SUBJECT: No Additional ESA or EFH Consultation Needed for Design Refinements
to the Graveline Bay Intertidal and Subtidal Reef Components, Restoring
Living Shorelines, Phase IV Early Restoration, Mississippi

Restoring Living Shorelines and Reefs in Mississippi Estuaries

Graveline Bay Intertidal and Subtidal Reef Component

Table 1. Graveline Bay Subtidal Reefs in Mississippi Estuaries-Design Refinements post ESA and EFH consultation

Figure 1: Conceptual project design proposed in the 2015 Final Biological Evaluation, Proposed Intertidal and Subtidal Reefs

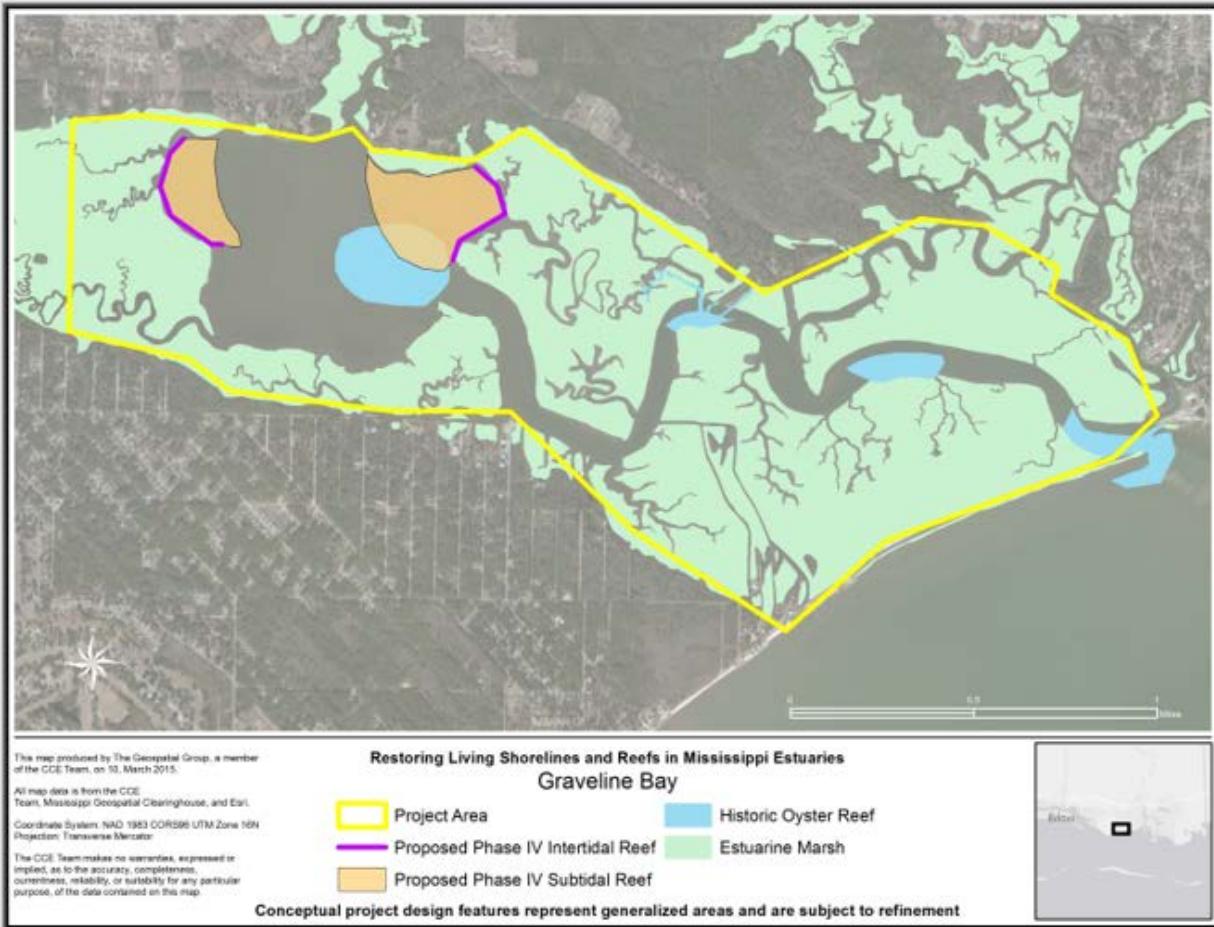
ESA consultations for the Graveline Bay Subtidal Reefs and Graveline Bay Intertidal Reefs were previously coordinated with NOAA NMFS (SER-2015-16960 and SER-2015-16959) and USFWS (2015-I-793) in 2015 and 2016. EFH consultations were coordinated with NOAA NMFS in 2015. In 2016, additional design refinements resulted in the anticipated locations of reef locations in Graveline Bayou. Since that time, due to various constraints, the reef locations have shifted back to locations entirely within Graveline Bay, and geotechnical and bathymetric studies and subsequent engineering design has been conducted for the project. The Final Basis of Design Report includes the placement of a minimum of 2 acres of intertidal reef in southern Graveline Bay and approximately 10 acres subtidal reef in southern Graveline Bay, in an integrated subtidal/intertidal reef design. Please note that the new final design reduces the subtidal reef acreage from 70 acres to a maximum of 10 acres, while the intertidal acreage remains at 2 acres.

Figure 4: Current Design Graveline Bay Subtidal Reef in Plan View

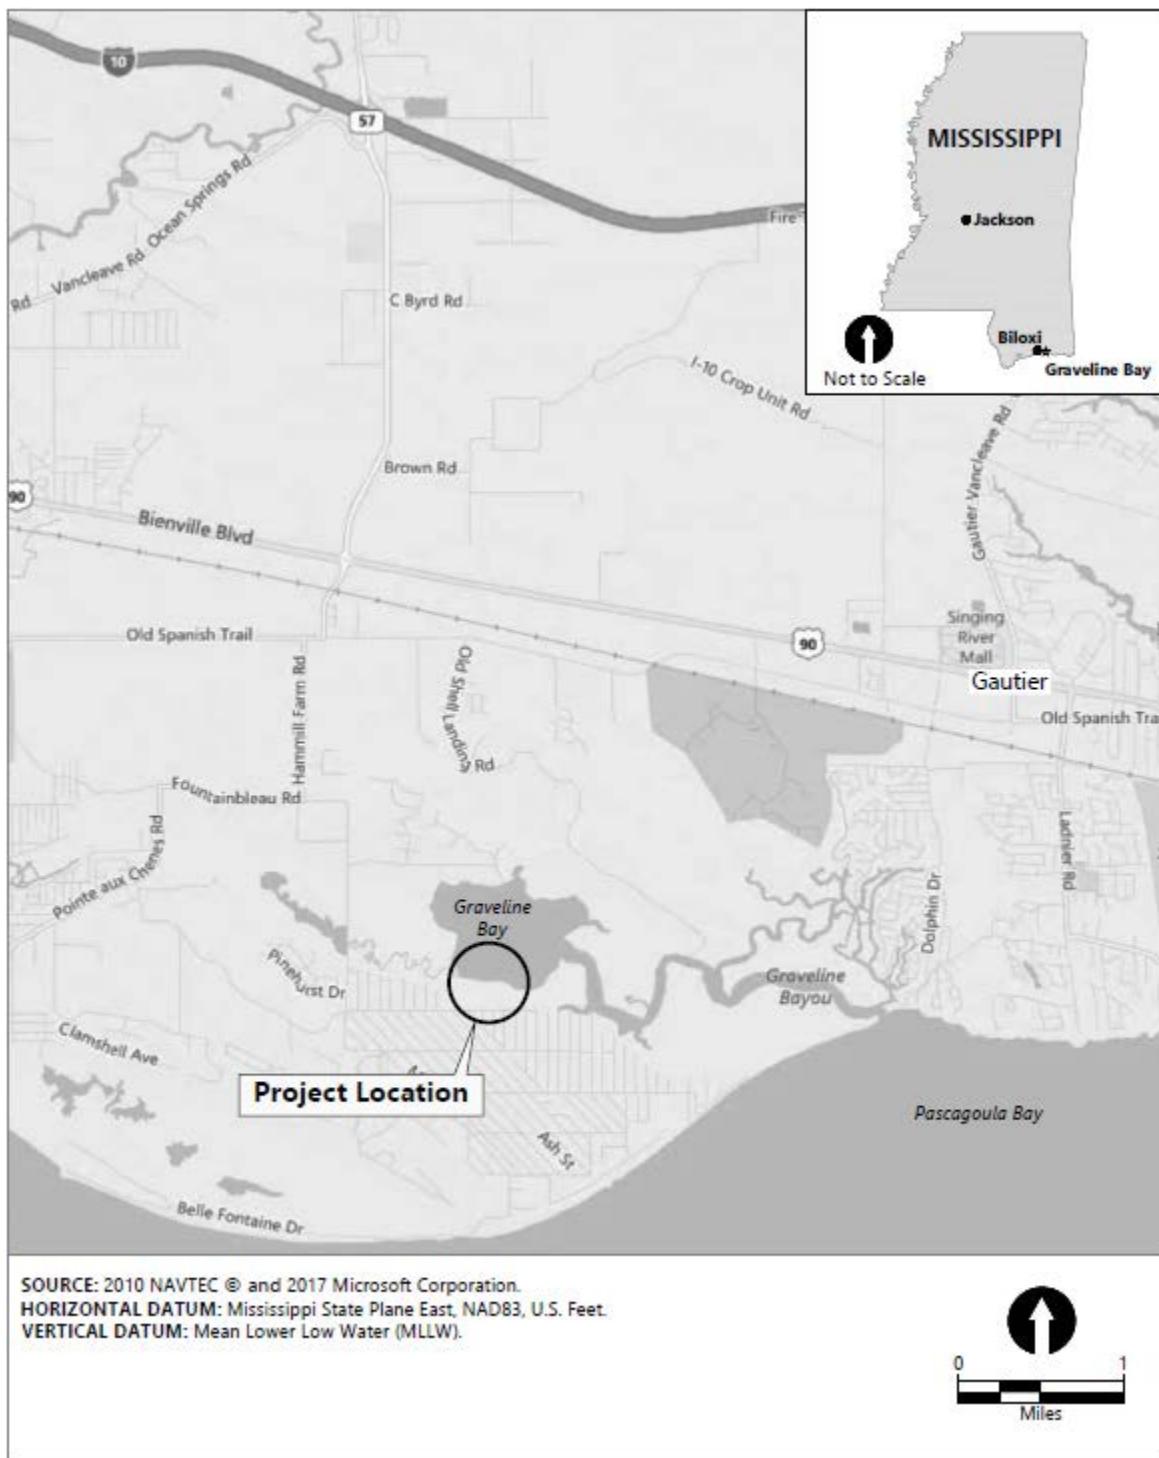
Project Element	Parameters	2015 BE	2016 BE	Current Design-Integrated Subtidal/Intertidal Reef
Subtidal Reef	Acreage	Up to 70 acres in Graveline Bay	up to 70 acres in Graveline Bay and Graveline Bayou	12 acres (maximum) (estimated 10 acres subtidal, minimum 2 acres intertidal)
	Construction materials	Approved cultch material (limestone, crushed concrete, oyster shells or combination thereof)	Limestone, crushed concrete, oyster shells or a combination thereof	Aggregate (stone or processed concrete and native or fossilized oyster shell. Other materials may be found or developed (could include concrete components with additives to enhance spat set or shell fish growth).
	Thickness	1 – 12 inches	1 – 12 inches	0.2 foot to 1.0 feet in undulating ridges
	Volume of materials	56,490 cubic yards	56,490 cubic yards	Up to 9,500 cubic yards
	Substrate	Unconsolidated soft bottom and mud	Unconsolidated soft and hard bottom (sand, muddy sand, mud bottom and remnant reef)	4 to 7 feet of soft sediment, underlain by a firm marine clay bearing layer.

Water depth	0 – 10 feet MLLW	No greater than 0-10 feet MLLW	0 ft to – 1.5 ft MLLW

Figure 5: Current Design Graveline Bay Subtidal/Intertidal Reef in Profile View

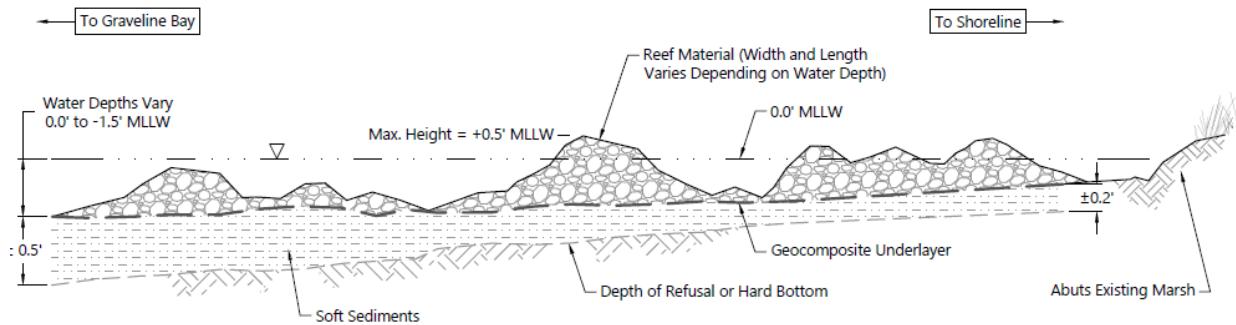
NOTE: Soft sediments will be compressed, displaced, or partially compressed by reef materials, leaving aggregate on the surface for shellfish habitat. Minimal material thickness between ridges.
